Access Compliance Report Public Rights-of-Way (Curb Ramps)

Main Street: ROOSEVELT_AVE Cross Street: ADAMS_ST Location: SE

ADA ID: RPRK211001144800 Ramp Type: Type 1 - Perpendicular Diagonal Initial Pass/Fail: Fail Overall Compliance: No Severity Score: 16

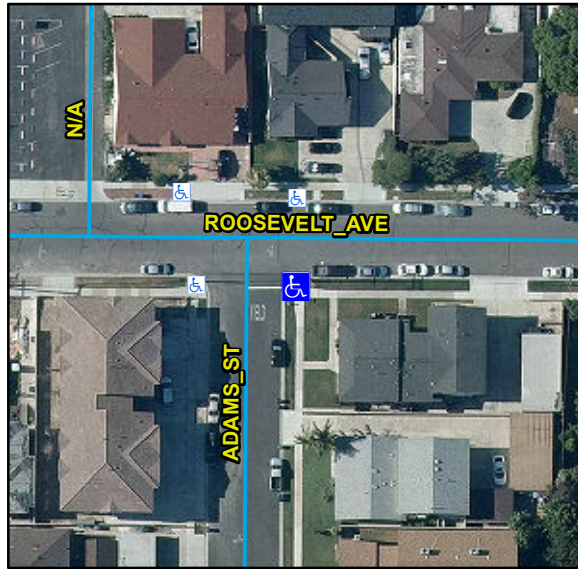
Compliance	Description	Data	Compliance	Description	Data
N/A	Ramp Length (in)	120	N/A	Flare Type LT	
Yes	Ramp Width (in)	48			N/A
No	Ramp Run Slope (%)	11.5	N/A	Flare Slope LT (%)	N/A
No	Ramp Cross Slope (%)	2.8	N/A	Flare Traversable LT	N/A
N/A	Landing Present	N/A	N/A	Flare Type RT	
N/A	Landing Length (in)	N/A			N/A
N/A	Landing Width (in)	N/A	N/A	Flare Slope RT (%)	N/A
N/A	Landing Run Slope (%)	N/A	N/A	Flare Traversable RT	N/A
N/A	Landing Cross Slope (%)	N/A	N/A	DWS Provided	N/A
N/A	Landing Movement Obstructed?	N/A	N/A	DWS Contrast	N/A
	Landing Movement Type	N/A	N/A	DWS Length (in)	N/A
N/A	Landing Shared	N/A	N/A	DWS Full Width	N/A
N/A	Clear Space	Yes	N/A	DWS Offset Left (in)	N/A
N/A	Clear Space To Crosswalk (in)	N/A	N/A	DWS Offset Right (in)	N/A
N/A	Marked Crosswalk 1	No	N/A	Marked Crosswalk 2	No
	Crossing 1 Direction	N		Crossing 2 Direction	W
	Marked Crosswalk 1 Width (in)	N/A		Marked Crosswalk 2 Width (in)	N/A

Remove & Replace Curb Ramp With Two New Directional Ramps or Equivalent.
